🔏 CT7-2E1 ALERT SERVICE BULLETIN - 72- A0028 R02

SB 72-A0028 R02 ENGINE - STAGES 1 AND 2 LOW-STRESS GGT ROTOR ASSEMBLY (72-41-00) -CT7-2E1 R88 CONTAMINATED HARDWARE REPLACEMENT

REVISION 2 TO ALERT SERVICE BULLETIN 72-A0028

Revision 2 is issued to update the applicable engine serial numbers in paragraph 1.A., Effectivity, and the List of Affected CT7-2E1 Serial Numbers and Components in Table 1.

Stages 1 and 2 Low-Stress GGT Rotor Assembly Disks and Cooling Plates Figure 1

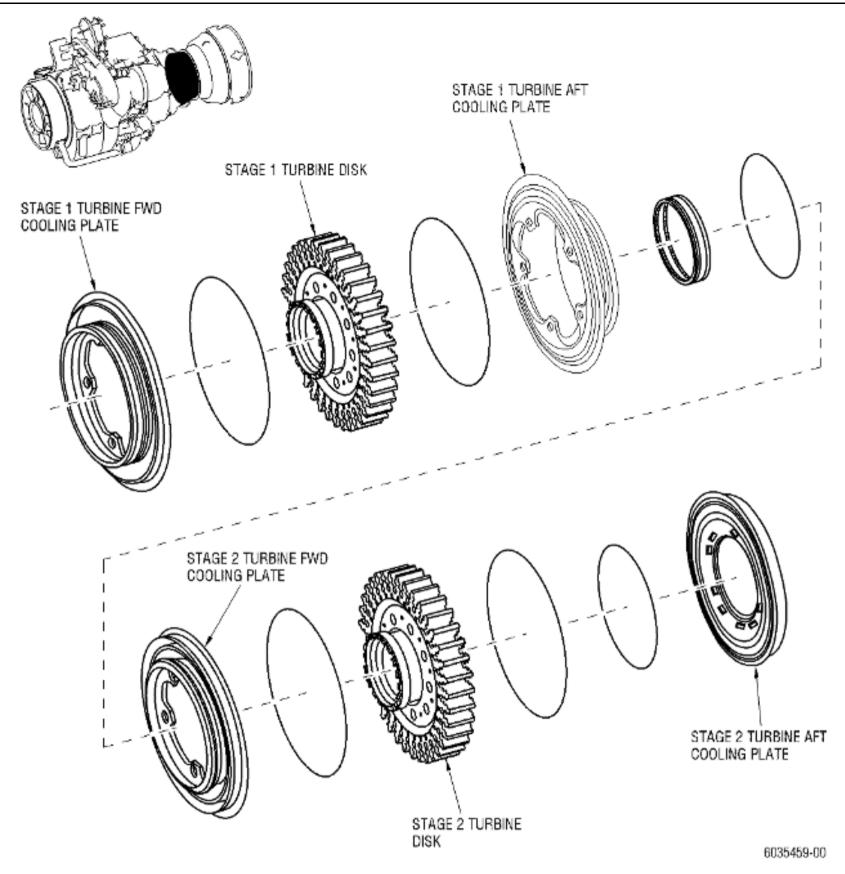
- (1) Remove the gas generator turbine rotor and stator assembly containing the potentially non-conforming stage 1 turbine disks (refer to figure 1). Refer to CT7-2E Maintenance Manual, GEK 112043-02, 72-40-00, REMOVAL AND INSTALLATION, TASK 72-40-00-400-801, applicable paragraphs.

- (2) Install a replacement matched gas generator turbine rotor and stator assembly P/N <u>5176T38G01</u>. Refer to CT7-2E Maintenance Manual, GEK 112043-02, 72-40-00, REMOVAL AND INSTALLATION, TASK 72-40-00-400-801, applicable paragraphs.
